## **GAINES SUBDIVISION**

Engineering Comments: FINAL PLAT COMMENTS (should be addressed prior to submitting the FINAL PLAT for review and/or signature by the City Engineer):

APPLICATION NUMBER 7 DATE January 20, 2022

# DETAIL SITE PLAN

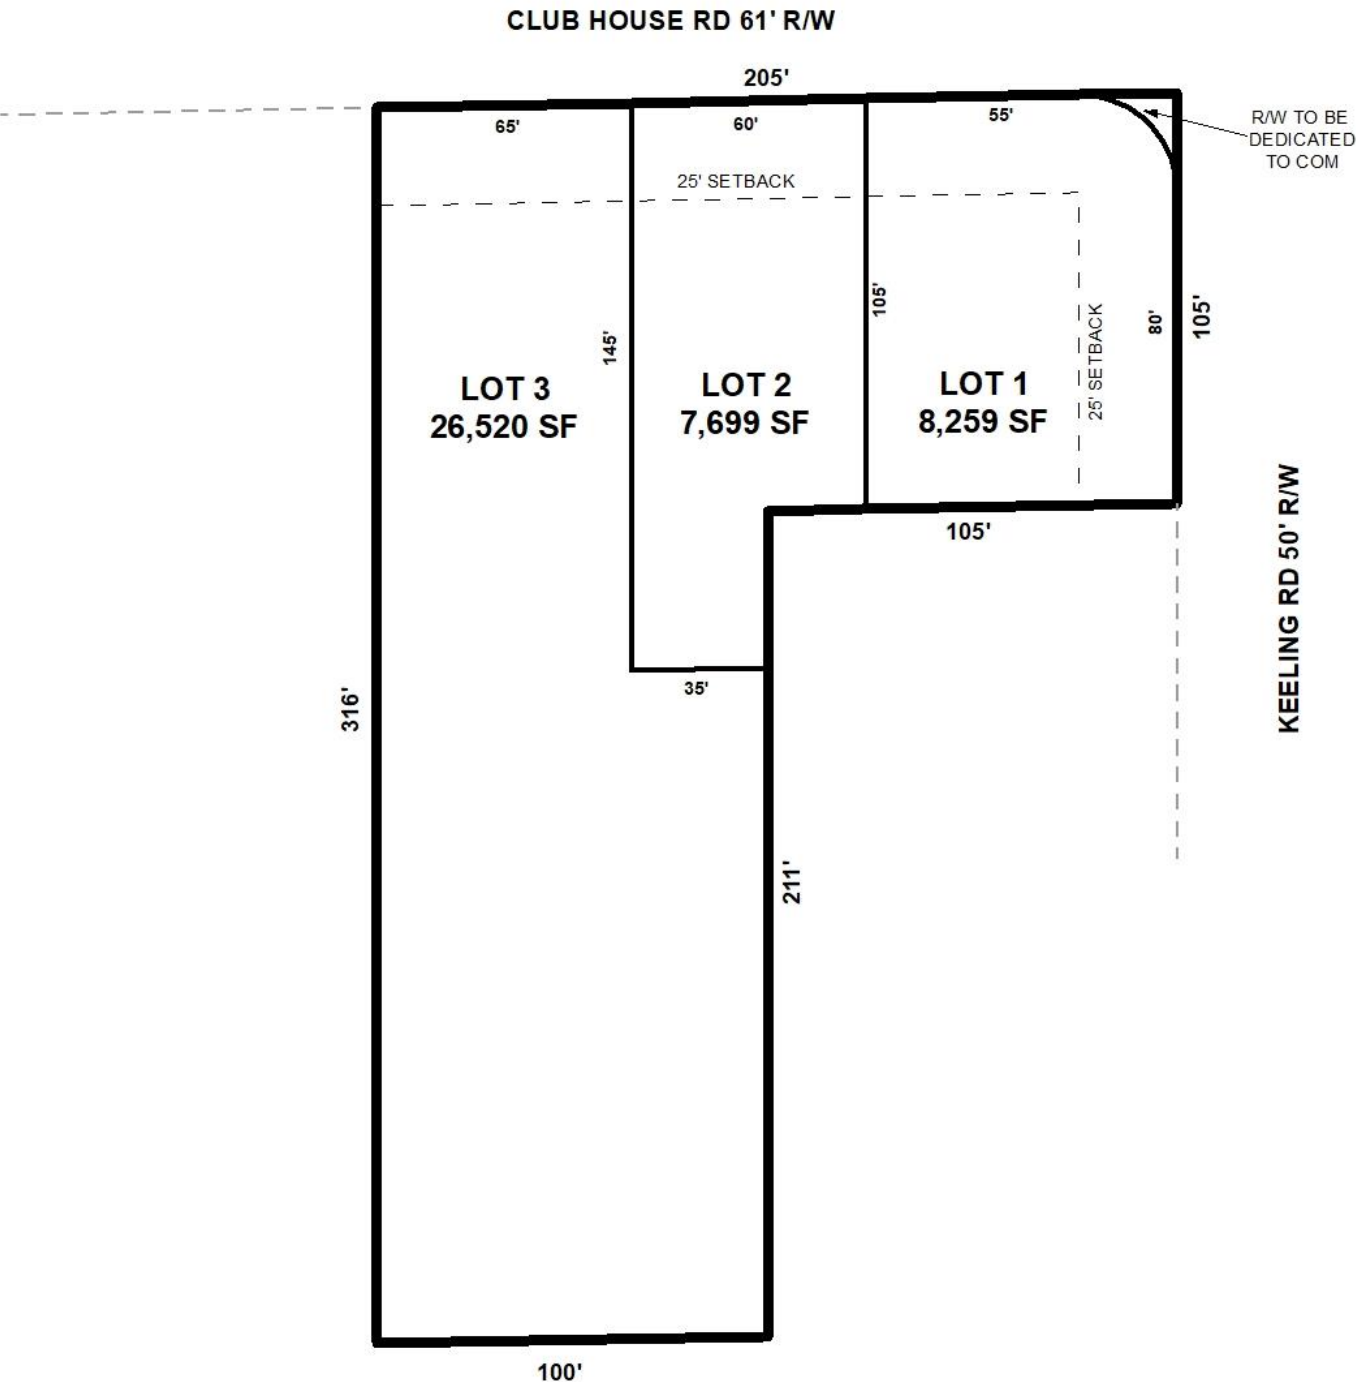
- B. Provide reference, on the map and the description, to a monumented corner.
- C. Provide and label the monument set or found at each subdivision corner.

- D. Add a graphic scale.
- E. Provide a written description for the subdivision boundary.
- F. Revise the note for the ROW Dedication from “ROW to be dedicated...” to “ROW hereby dedicated...”.

- G. Provide the amount of acreage (sf) being dedicated.
- H. Show and label all flood zones. New maps went into effect on June 5, 2020.
- I. Add a signature block for the Owner, Notary Public, Planning Commission, Traffic Engineer, and City Engineer.

- J. Provide the Surveyor’s Certificate.
- K. Provide the Surveyor’s and Owner’s (notarized) signatures.
- L. Add a note to the SUBDIVISION PLAT stating that as shown on the 1984 aerial photo (FLIGHT 26 - #90) LOTS 1, 2 and 3 will receive historical credit of existing (1984) impervious area towards stormwater detention requirement per Mobile City Code, Chapter 17, Storm Water Management and Flood Control) as follows: LOT 1 – 1,800 sf, LOT 2 – NONE, and LOT 3 – 2,200 sf.

The site has frontage on Clubhouse Road and Keeling Road, both of which are minor streets. Clubhouse Road has no curb and gutter, but has a compliant 61-foot right-of-way. Keeling Road has curb-and-gutter with a compliant 50-foot right-of-way. Therefore, no dedication would be required along the street frontages. As on the preliminary plat, the rights-of-way of both streets should be retained on the Final Plat, if approved. The 25-foot corner radius dedication at the intersection of Clubhouse Road and Keeling Road should be retained on the Final Plat, if approved.

The plat indicates a 25-foot minimum building setback line along both street frontages and this should be retained on the Final Plat. The proposed lots meet the minimum size requirements of the Subdivision Regulations. As on the preliminary plat, the lot size labels in both square feet and acres should be retained on the Final Plat, or a table should be furnished on the Final Plat providing the same information. Lot 3 would exceed the maximum width-to-depth ratio as recommended by Section V.D.3. of the Subdivision Regulations. However, as many of the lots in the surrounding area also exceed that ratio, a waiver of Section V.D.3. would seem in order.

- 1) retention of the right-of-way widths of Clubhouse Road and Keeling Road on the Final Plat;
- 2) retention of the 25-foot corner radius dedication at the intersection of Clubhouse Road and Keeling Road on the Final Plat;
- 3) retention of the 25' minimum building setback line along Clubhouse Road and Keeling Road on the Final Plat;

- 4) retention of the lot size labels in both square feet and acres on the Final Plat, or the furnishing of a table on the Final Plat providing the same information;
